Reviewer #2 comments

The paper reports on the development and on a field test of an UAV-based active AirCore system for measurements of greenhouse gases. The subject of the paper fits AMT perfectly; it describes a method that bears a lot of potential for future research on GHG fluxes on scales of 100's to 1000's of meters. It is an important contribution to this field of research and should thus be accepted for publication – but only if the comments below are adequately and fully addressed.

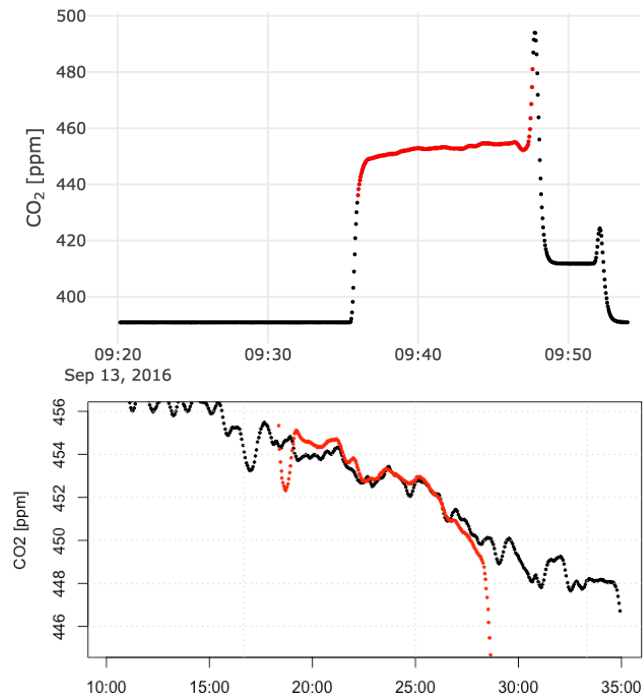
16/Fig.7: The titles above the graphs are not necessary. What are the fine dots in 7.c? As the five flights were so few and different it is difficult to say anything concrete on the quality or interpretation of the flights (particularly on flight #1). I therefore strongly suggest avoiding highly speculative interpretation attempts (as in 18/6-9). Some retro trajectories might help (even if a trajectory does not explicitly give information of the fluxes), but that might be already beyond the scope of this paper. 7 a and b are so much zoomed out that we can only poorly evaluate the performance of AirCore vs.tower – Table 4 is more helpful – some discussion is needed on why flight #3 seems to be giving the "best fit" profile, judging from Table 4 (even if there was no data recorded on the SD card).

- Titles have been removed.
The fine dots in Figure 7 (c) represent the CO data points with a time resolution of 3. The lines are drawn with a 5 data point average, as stated in the figure description. We've added a sentence in the figure text stating that each dot represents a data point:
"... , with each dot representing a data point with a time resolution of 3 seconds. ...". Added a possible explanation as to why the fit seems to be better for the third flight: "... From table 4, it is seen that the best fit

between data and atmospheric tower data occurred during the third flight. A possible explanation for this could be the smaller variability of mole fractions within the boundary layer. ...”.

We decide to keep the sentence that CO₂ may have been originating from Eemshaven (east of Lutfjewad), because this is the most likely interpretation we have based on available information. However, we have added more information to the matter, by including an additional sentence: "... Hysplit backward trajectories show that the winds emanated from the south-east during the time of the campaign. ...”.
